## **ALERT SERVICE BULLETIN**

**205-24-122**

**MODEL AFFECTED:** 205A/205A-1

**SUBJECT:** INSPECTION OF CAP ANGLE, P/N 205-030-207-005, INTRODUCTION, OF.

**Figure1. Fuselage Tailboom Attachment Inspection.**

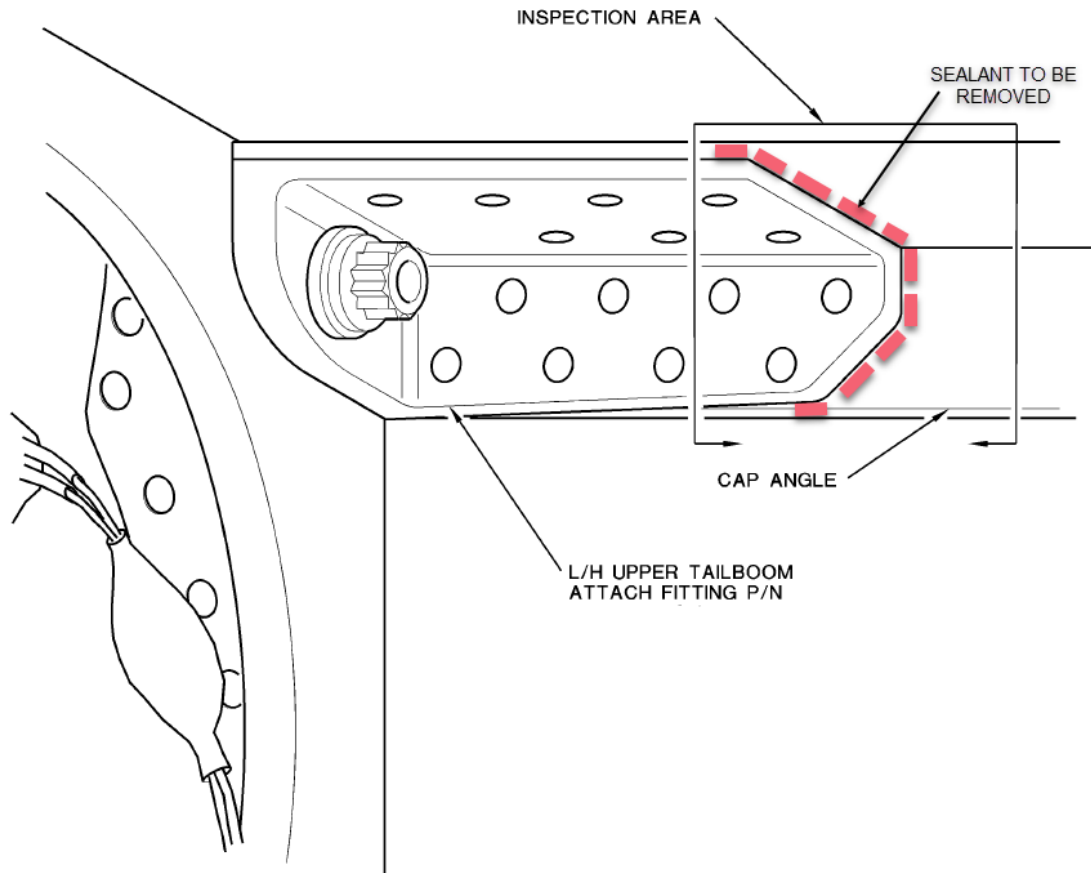
2. If sealant is present, remove sealant from edge of fitting (Figure 1).
3. Inspect the cap angle area shown with a 10x magnifying glass and bright light.
4. If a crack is found, replace the cap angle before further flight. If the helicopter is at a location where the cap angle cannot be replaced, contact Product Support Engineering.
5. Touch up primer if damaged during sealant removal. Paint touch up is optional. Do not reapply sealant.
6. If no cracks are found, the helicopter can be returned to service.
7. Make an entry in the helicopter logbook and historical service records indicating findings and compliance with this Alert Service Bulletin.
